AMENDMENT NO. 2 JUNE 2003
TO
IS 459 : 1992 CORRUGATED AND
SEMI-CORRUGATED ASBESTOS CEMENT
SHEETS —SPECIFICATION
(Third Revision)

FIG. 1A CORRUGATED SHEET WITH FULL OVERLAP

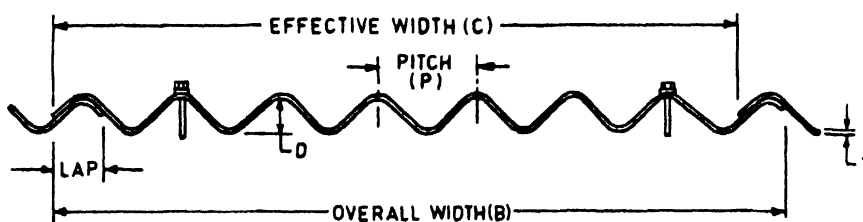
'NOTE — Corrugated sheets of overall width 1 086 mm and effective width 1 016 mm with tolerances and other parameters same as in this table 1 may also be manufactured by mutual agreement between the manufacturer and the purchaser (see Fig 1A)'

(Page 3, Fig. 1) —Insert Fig. 1 Aafter 'Fig. 1'.
